18 June 2019

**Subject: Response to Selected Comments Presented at Public Hearing
Permit Modification Application for Vertical Expansion
Delaware Recyclable Products, Inc. Landfill
New Castle, New Castle County, Delaware**

Figure 1. Three phase diagram of waste, leachate, and air without and with overburden.

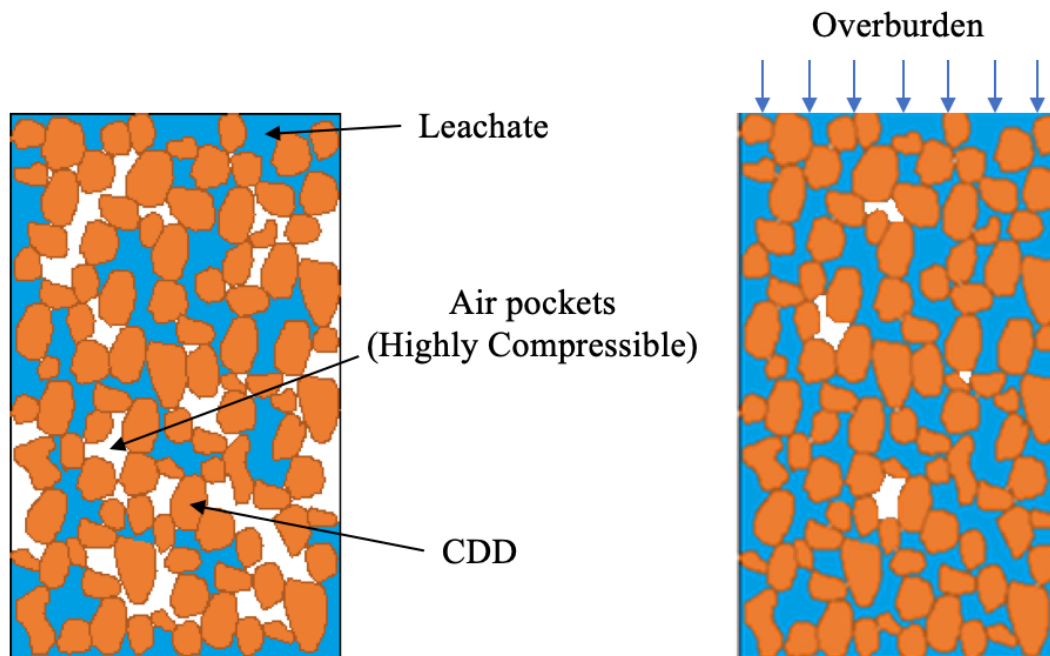
Additionally, the implication made in Artesian's testimony is that compression due to the additional waste loads would cause liquids to be released from the unlined waste below the Cells 1-3 overlay liner system. Geosyntec has evaluated the loading mechanisms at the DRPI Landfill during landfilling and, as subsequently described, has identified three factors that will likely reduce the leachate flow. In addition, because the area of concern has been lined, additional leachate in the waste mass underlying the overlay liner system will not be generated due to the proposed vertical expansion. Thus, the proposed vertical landfill expansion will not contribute to an increase in the total volume of leachate and may actually result in a reduction in the leachate generation rate. The three factors that will likely reduce leachate flow are as follows.

- **Compression of, and leachate flow into, air pockets.** Air permeability inside the landfill is very low (10^{-12} cm/s) which leads to large volumes of air entrapped inside the landfill (Jain et al. 2006). This characteristic essentially makes any leachate flow a three-phase

system (Figure 1). Henrych (1979)¹⁰ and Wang et al. (2005)¹¹ showed that air is highly compressible. Therefore, because of the low overall landfill permeability, an increase in overburden will cause air volume to reduce and leachate to flow into the surrounding air voids. A sketch depicting this concept is presented in Figure 1.

Diagrammatic cross-section showing stratigraphic relationships
(Not to Scale)

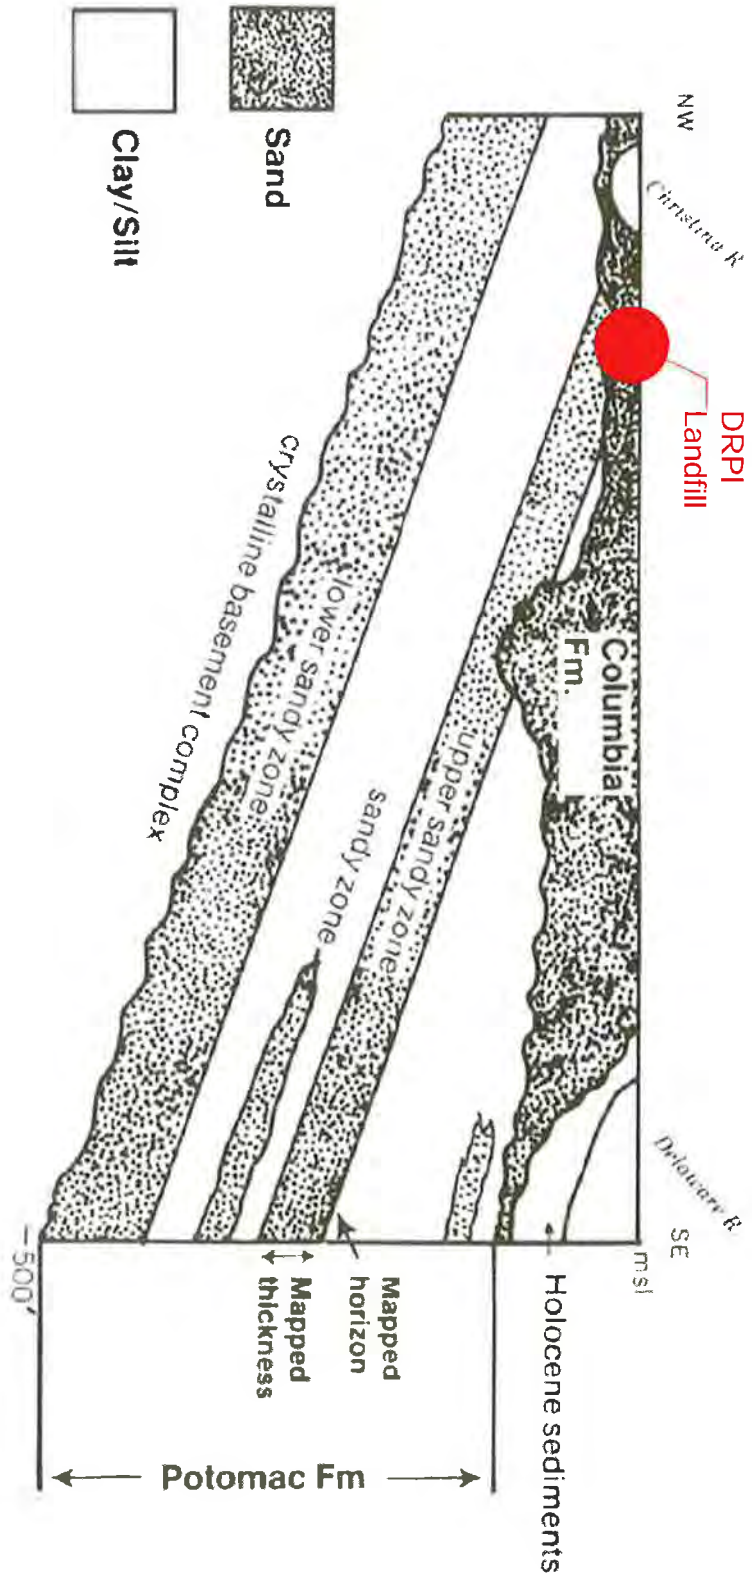
- ‘Submission’, *Diagrammatic cross-section showing stratigraphic relationships (Not to Scale)*¹⁷ is a schematic conceptual cross section that is a portion of Sheet 4 (Structural Geology) showing generalized information on the depth and thickness of the ‘upper sand zone’ of the Potomac Formation, and has the approximate location of DRPI Landfill added to the figure; and
- ‘Submission 2’, is a portion of Sheet 3, *Structural Geology, Elevation of the Base of Sand in the Upper Part of the Potomac Formation*¹⁸ with the approximate locations of DRPI Landfill and Artesian’s well fields added to the figure.

10 MR. DEMICCO: First and foremost is
11 here is a schematic from Delaware Geological
12 Survey publication with a reference -- I will
13 give to DNREC that we want these added into the
14 record formally -- that are from 1984
15 Geological Survey publication, and the first
16 one is basically a schematic of the aquifers we
17 have all been talking about.

18 The landfill is located on top of
19 the Potomac aquifer. And they have excavated
20 down into that aquifer. The problem is you
21 couldn't pick a worse site to put a landfill if
22 you were trying.

Potential DRPI Leachate Migration to Upper Sandy Zone of Upper Potomac Formation. It is presumed for several reasons that Artesian is concerned about potential landfill leachate migration pathways through the Upper Potomac Formation ‘upper sand zone’ to their supply wells. First, Artesian plotted the locations of the landfill and their wells on Submission 2 that shows structure contour information specific to the base of the upper sand zone of the Upper Potomac Formation. Second, Artesian plotted the landfill location on the schematic cross section at a location directly above the subcrop of the upper sand zone. Presumably, Artesian inferred from the conceptual cross section they submitted that there would be direct recharge of potential leachate releases from the landfill into the subcrop of the upper sand zone of the Upper Potomac Formation. The schematic cross section erroneously shows the shallow Columbia Formation aquifer in direct unconformable contact with the underlying subcrop of the upper sand zone of the Upper Potomac Formation without any intervening clay aquitard. The stratigraphy presented on the schematic cross section (Attachment 1 Submission), without any clay between the bottom of the landfill and the upper sand zone of the Upper Potomac Formation, is inconsistent with the site-specific soil boring information used to produce the subsurface stratigraphy shown in Attachment 2.

Furthermore, Artesian did not submit the more detailed cross section on Sheet 1 (B-B’) from the same Delaware Geological Survey document that they consulted for their submittals (see Attachment 5). Delaware Geological Survey’s cross section B-B’ is drawn to scale using specific soil boring log information and passes through the landfill location. B-B’ shows the presence of a substantial clay aquitard at the landfill location. The clay aquitard separates the surficial materials of the Columbia Formation (that were removed by sand and gravel quarry operations) and the upper sand zone of the Upper Potomac Formation. Sheet 1 of the Delaware Geological Survey report has text in the top right indicating for the northern area of the map (i.e. the DRPI Landfill vicinity) the upper sand zone of the Upper Potomac Formation is thin and irregular in thickness and areal extent and is therefore consistent with the site soil borings and the fence diagram in Attachment 2. The text box on the top left of Sheet 4 indicates that the upper sand zone is not always persistent along strike in the subcrop area (it is noted that the northwest portion of DRPI Landfill is located within the subcrop area). Cross Section B-B’ shows that there is a clay aquitard separating the (previously quarried) Columbia Formation and the upper sand zone of the Upper Potomac Formation beneath the landfill and to the south of the landfill toward the public supply wells. Cross section B-B’ goes through the site between borings Cd31-16 and Cd31-4 and shows that there is clay present above the upper sand. The schematic cross section submitted by Artesian and is, therefore, misleading because it does not show the presence of the thick clay aquitard between the landfill and the upper sand horizon. The boring logs for the landfill permit applications also show the presence of the clay aquitard between the landfill and the upper sand zone as depicted in Attachment 2¹⁹. Therefore, there is not a direct connection from beneath the
